Assessment Report

Pedestrian, Bicycle, and Transit

City Of Lawrence, Kansas 19th Street from Iowa to Barker

Practical Road Safety Assessment

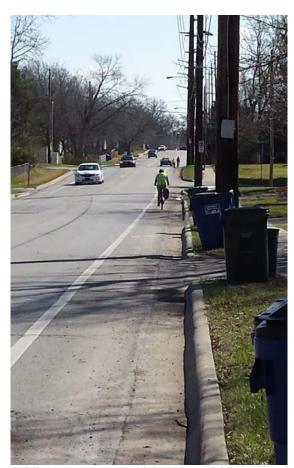
Bicycle: Except where there are bike lanes, bicyclists must share the road with high traffic volumes including commercial vehicles. Vehicles were observed not giving the required 3' passing clearance.

Discussion: This is generally a two lane street with a center turn lane from about Alabama St. to Kentucky St. and at other major intersections in the corridor. Two segments have bicycle lanes, between Naismith and Alabama and east of Massachusetts St. Only experienced riders should use 19th St., particularly from west of Tennessee to east of Kentucky where there is less than desirable pavement condition and an auxiliary lane which may cause confusion.

Shared lanes generally work well with low vehicle volumes. A curb lane greater than 14' allows a motorist to pass a bicyclist with an adequate comfort clearance of greater than 3'. Bicycle lanes are used to designate a preferential use of the roadway for bicyclists. The existing roadway does not have adequate width for either wider curb lanes or additional bike lanes in its current configuration.

<u>Lower Cost</u>: Consider a parallel alternate route on 21st St. for a bicycle boulevard. This much lower volume residential street would be safer and favorable to less experienced riders.

Initiate an education campaign to bring public attention to the 3' passing law. Suggest it correspond with the start of school in September.

Provide "Shared-Lane Marking" to fill gaps between segments with bike lanes particularly where lanes are too narrow for a bicyclist and a motorist to travel side-by-side and to eliminate any confusion as to where a bicyclist should be when extra lanes are present.

Provide timely street cleaning for bike lanes and along curb where a bicyclist will normal ride to remove sand and other debris.

<u>Higher Cost</u>: Reconstruct to 3-lanes with bike lanes (planned between Iowa and Naismith; but bike lanes are not shown on planning map).
